MANDATORY SERVICE BULLETIN No. Z 143L/6a

1. **MODELS AFFECTED:** All Z 143L aircraft up to S/N 0009, excepting S/N 0008. Aircraft S/N 0008, 0010 and up are manufactured in compliance with this bulletin.

2. **SUBJECT:** Release of the front seat can occur.
3. **CORRECTION:** Replace bolts which attach cubes of the front seat and replace spring washers with tab washers.

Fig. 1 Front seat

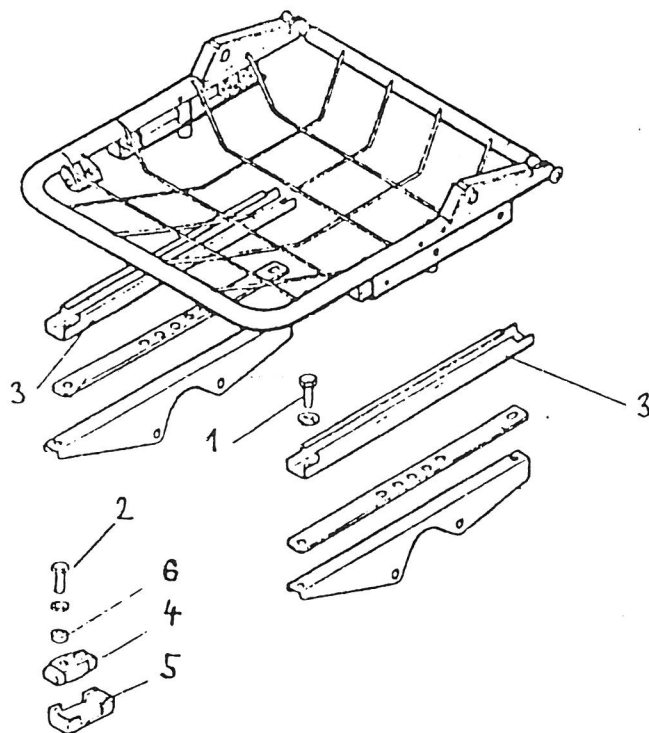
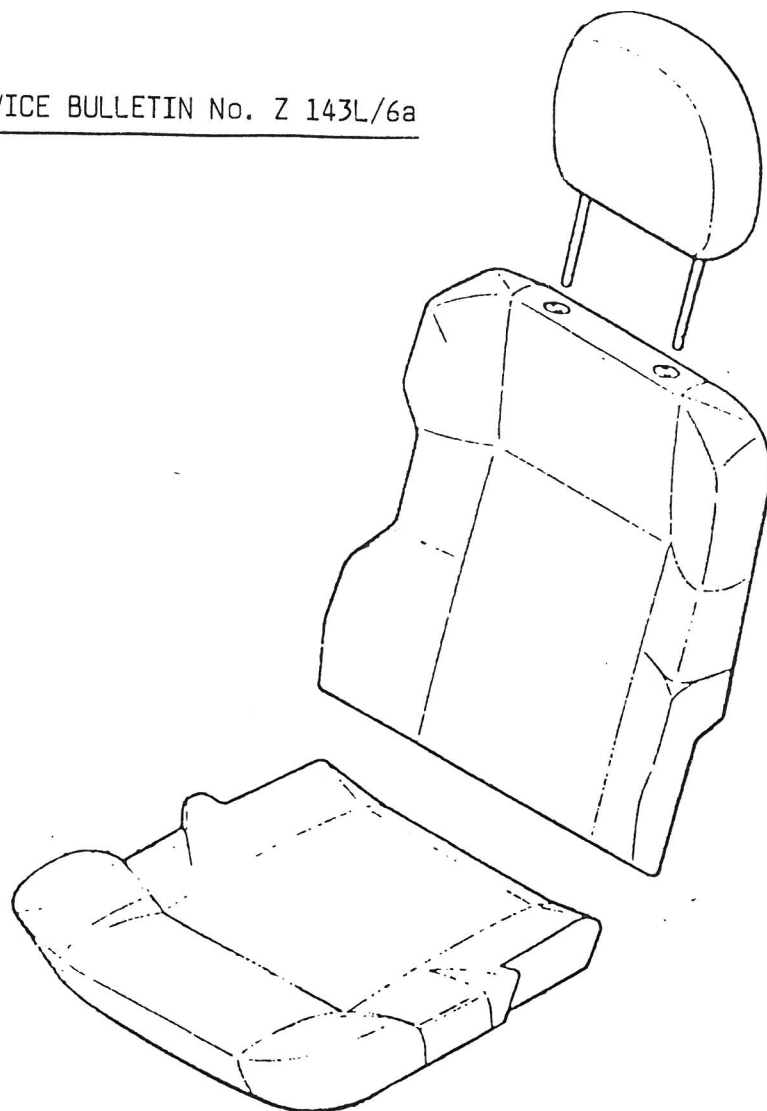
7. **PROCEDURE:**
 1. Unscrew 4 bolts M8 (Item 1) which attach the seat in aircraft and remove the seat (Fig. 1).
 2. Release snap hooks and hooks on the seat bottom part and remove the cover (Fig. 2).

3. Remove the seat filling from the seat.
 4. Loosen 4 bolts M8 (Item 2), (Fig. 1).
 5. Depress the seat arrestment handle and remove guides (Item 3).
 6. Remove guide bushings (Item 5) from guide cubes (Item 4) and unscrew fully bolts M8. Remove bushings (Item 6) from bolts and take out bolts with spring washers from the seat.
NOTE: When removing rear bolts, push the arrestment cable of seat aside. This cable need not be released.

7. Put tab washers on new bolts M8 so that the tab is directed towards the longitudinal axis of the seat and insert bolts with washers in place of original ones.

8. Put bushings (Item 6), cubes (Item 4) on bolts and screw bolts in (do not tighten them).
 9. Put bushings (Item 5) on cubes and re-install guides (Item 3) on cubes.

10. Tighten thoroughly all 4 bolts and check guides on cubes for free motion.
 11. Lock bolts by bending tab washers.
 12. Re-insert the seat filling into the seat.

13. Put the cover on the seat and re-attach snap hooks and hooks.
 14. Put the seat into the aircraft and fasten in by screwing-in 4 bolts M8 (Item 1).
8. NECESSARY MATERIAL: It will be delivered by the Manufacturer together with the Bulletin.
8 pcs of the bolt 8x21 ONL 3120.24
8 pcs of the washer 8.2 ONL 3288.1
9. THIS BULLETIN IS EFFECTIVE FROM THE DATE OF APPROVAL BY THE CIVIL AVIATION INSPECTORATE.
10. ENCLOSURE: Necessary material acc. to Sect. 8 of this Bulletin.
